WATER TREATMENT PLANT NO. 3 EXPANSION

No.	Date	Description
3	6/20/2022	ADDENDUM NO. 3

Sheet Title: WELL SITE Nos. 3,10, & 11 PLANS

H1 WELL SITE No. 10 PLAN 1/4" = 1'-0"

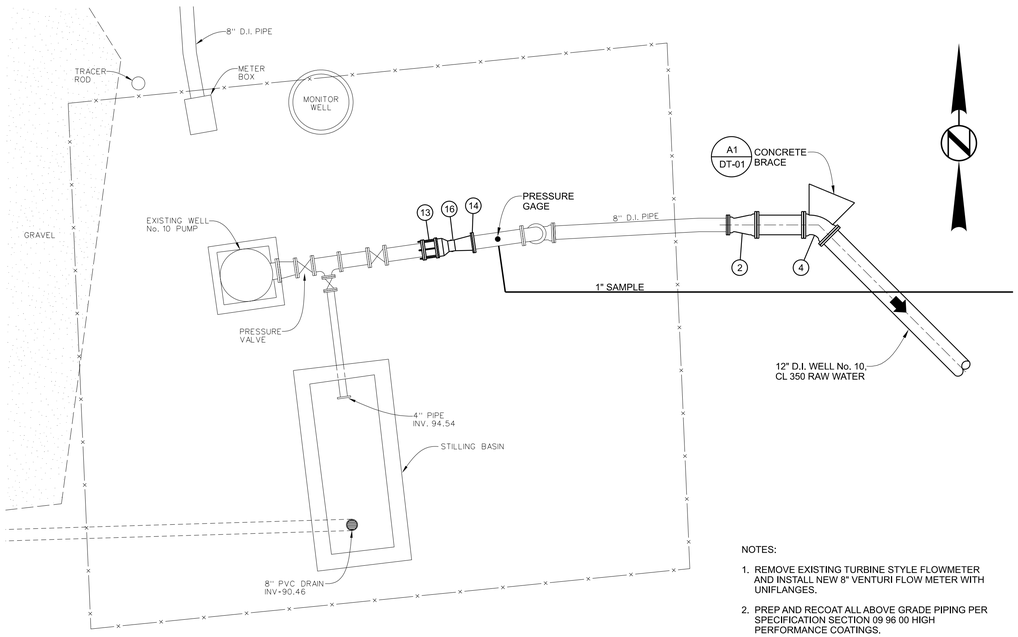
1. REMOVE EXISTING TURBINE STYLE FLOWMETER AND INSTALL NEW 8" VENTURI FLOW METER WITH UNIFLANGES.
2. PREP AND RECOAT ALL ABOVE GRADE PIPING PER SPECIFICATION SECTION 09 96 00 HIGH PERFORMANCE COATINGS.

H8 WELL SITE No. 3 PLAN 1/4" = 1'-0"

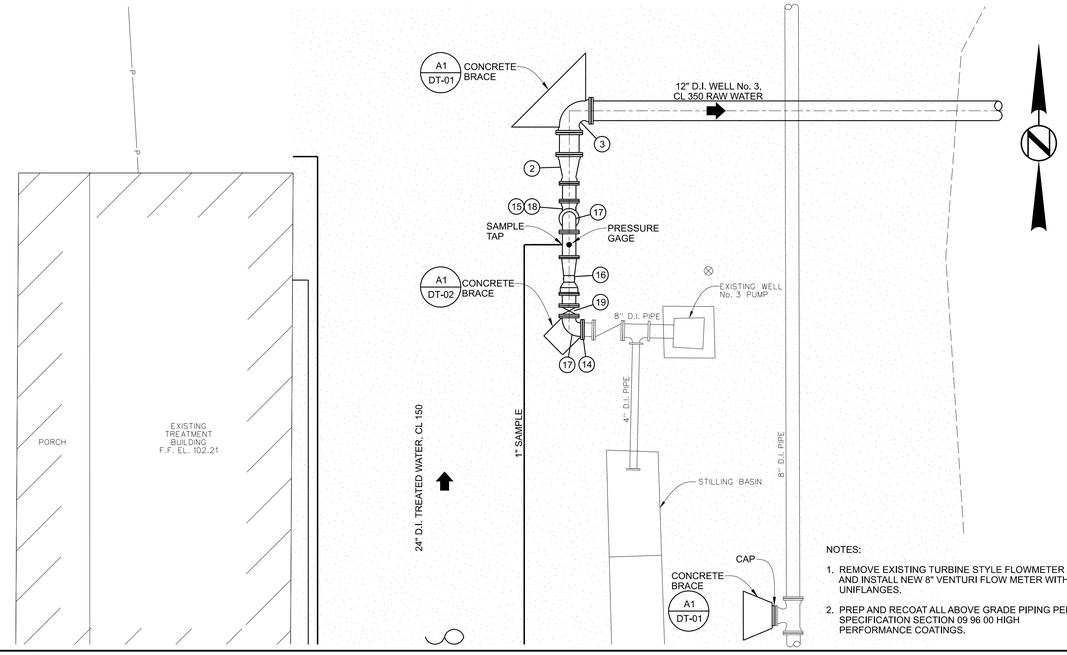
1. REMOVE EXISTING TURBINE STYLE FLOWMETER AND INSTALL NEW 8" VENTURI FLOW METER WITH UNIFLANGES.
2. PREP AND RECOAT ALL ABOVE GRADE PIPING PER SPECIFICATION SECTION 09 96 00 HIGH PERFORMANCE COATINGS.
